Docket Item # 4
BAR CASE# 2009-0051

BAR Meeting
June 3, 2009

ISSUE: Signage/Alterations
APPLICANT: Capitol Burger, LLC (Catherine Puskar, Agent)
LOCATION: 106-108 North Washington Street
ZONE: CD / Commercial

Figure 1: Proposed Blade Sign

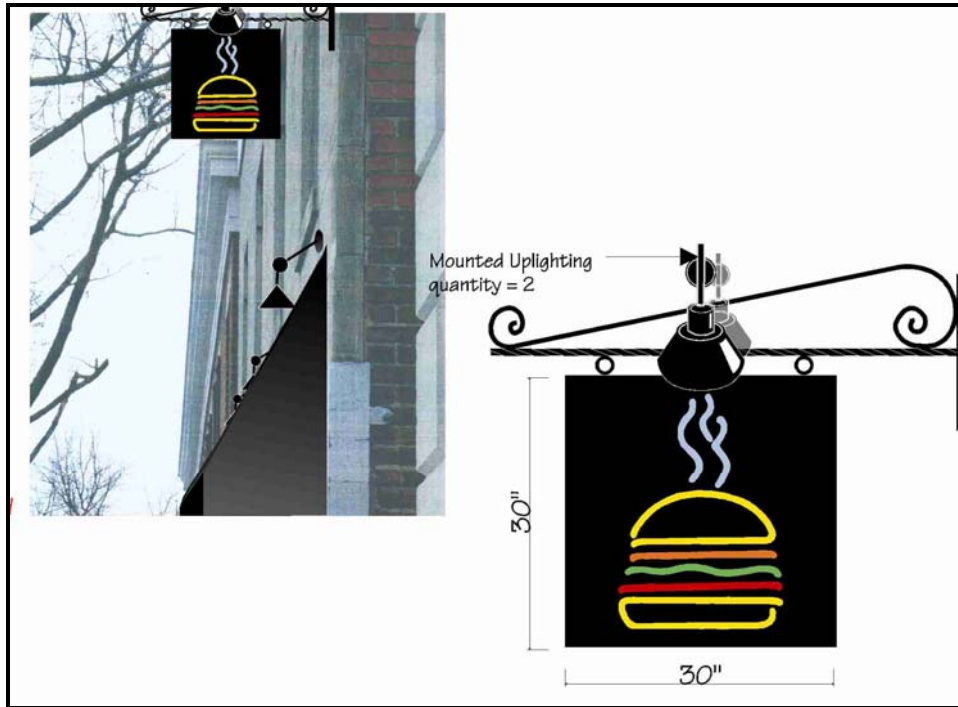
Although the most common material used for signs within the historic district is painted wood, the Board has been open to consider new sign materials. The proposed High Density Urethane (HDU) board proposed for the hanging sign has been approved in a few instances by the Board (Potomac Bead Company-*lettering*, The Hour-*signage material option*). Staff has reviewed the proposed material selection and does not object to its application for this project.

The *Design Guidelines* also advise that "signs should not be attached to a building in a manner which requires the removal of historic materials" and "individual letter signs should be blind mounted on the front of a building." These new features will be mounted to the building by utilizing

Figure 2: Proposed Awning

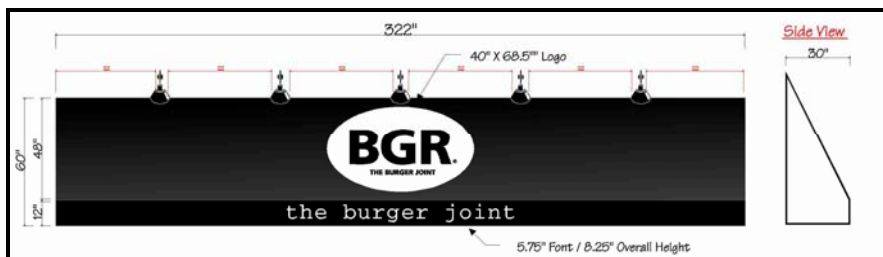
According to the *Design Guidelines*, "Signs should be designed in styles, materials, type faces, colors and lettering that are appropriate and sympathetic to the historic style of the building." The current design for the awning is a revision based upon size, detail and profile concerns expressed by Staff. The applicant responded to Staff's concerns by reducing the awning's height from 66 inches to 60 inches, the size of its logo from 42 inches x 72 inches to 40 inches x 68.5 inches and increasing the width of the awning from 24 inches to 30 inches. Staff was also concerned with the size of the blade sign and its original location in the center of the four, second-story windows. The applicant also altered this original design by reducing its size from 48 inches x 40 inches to 30 inches x 30 inches and locating the sign at the northern edge of the second floor. Finally, Staff has also expressed concern about the number of light fixtures proposed for the building. The applicant has articulated their need for the proposed lighting program as the Special Use Permit allows for their hours of operation to extend to midnight. However, Staff remains concerned that the number and size of the gooseneck lights proposed is excessive and should be reduced.

The proposed blade sign and awning are now more comparable in size and materials to others approved within the historic district and along Washington Street. While the proposed awning does not detract from the current style of the building, which is simple in design and void of ornamentation except for detailing at the roofline, it will obscure the multi-light window transom.

- C-2 Awnings must comply with all applicable requirements of USBC 3105.3 and 3202.3.1 Retractable and fixed awnings must have a minimum 7 foot clearance form a sidewalk to the lowest part of the framework or any fixed portion of any retractable awning is required. Retractable awnings must be securely fastened to the building and can not extend closer than 24 inches in from the curb line (USBC 3202.3.1).

- C-3 Fixed awnings must be designed and constructed to withstand wind or other lateral loads and live loads required by the USBC. Structural members must be protected to prevent deterioration (USBC 3105.3).
